Sonnblick Lodge Demolition - 10 Bobuck Lane, Thredbo

Development Application Assessment
DA 24/448

Subtitle: Development Application Assessment, DA 24/448

Figure 6 | Sketch of the proposed stabilisation measures after the demolition (Source: Applicant's documentation)

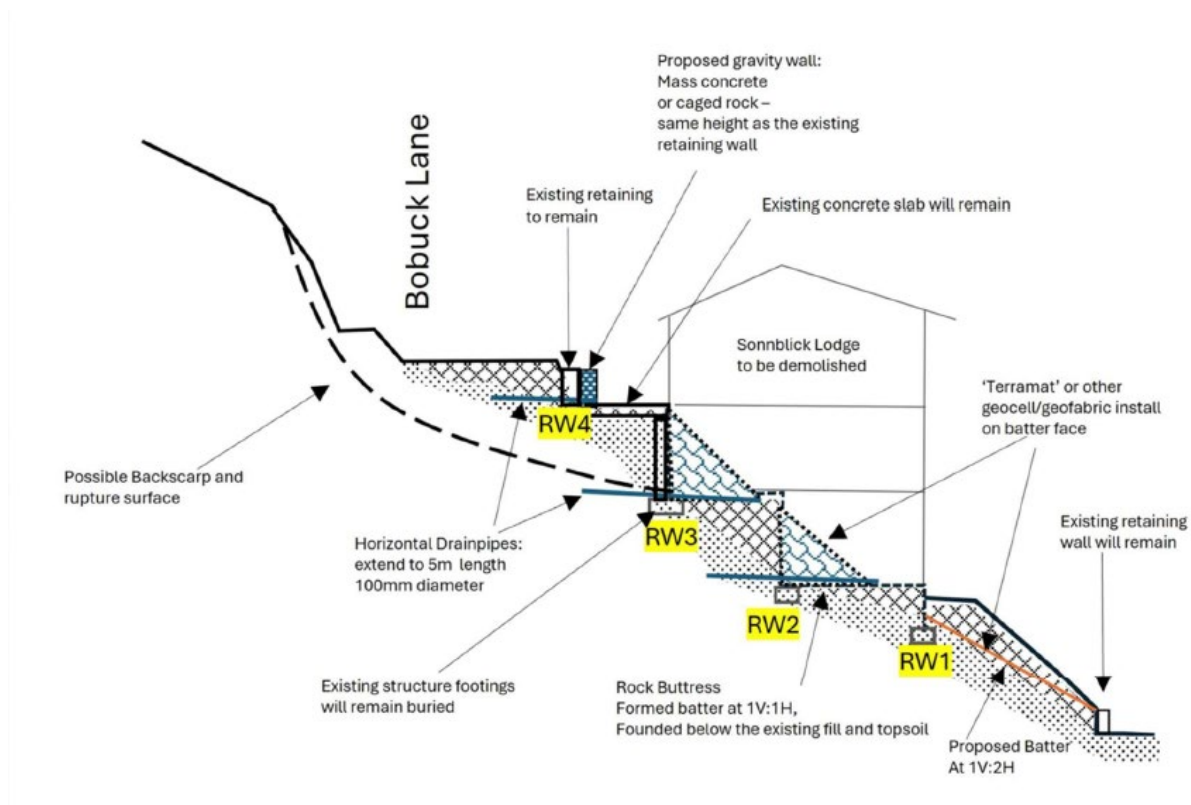
Additionally, it is noted that the new slope will comprise the existing retaining walls, requiring further stabilisation. Therefore, it is recommended that the existing retaining walls should incorporate the following (**Figure 6**):

- Retaining Wall 1 to Retaining Wall 3 (currently supporting Sonnblick Lodge) –
 - After the lodge demolition, a geotechnical engineer should also inspect the retaining walls and backfill material to estimate the sufficiency of the existing drainage.

- Areas in front of the existing retaining walls must be fully stripped of all silty topsoil and any uncontrolled fill/
 - Caged gabion walls or rock buttresses should be placed before the existing walls and battered back not less than 1V:1H.

- Retaining Wall 4 (Supports Bobuck Lane) –
 - Sub-surface horizontal drainage should be installed at the base of Retaining Wall 4.
 - The swale drain should be installed at the toe of the retaining wall to direct the stormwater away from the new slope into the Thredbo stormwater system.

- There are two options for the stabilisation of the upper faces. Option 1 includes shotcrete the upper faces, while Option 2 may include caged gabion walls installed in front of the existing Retaining Wall 4 up to the level of Bobuck Lane.

- The Societal Risk Assessment Plot provided in the geotechnical assessment (for before and after the works) indicates that the demolition of the lodge and accompanying earthworks will reduce the associated risks once the works are completed.

- Overall, the measures outlined in the geotechnical assessment to manage and mitigate potential risks during and after the works are adequate. Nonetheless, leaving the site vacant for extended

To ensure the demolition works avoid and mitigate potential risks, the Department has recommended the following conditions:
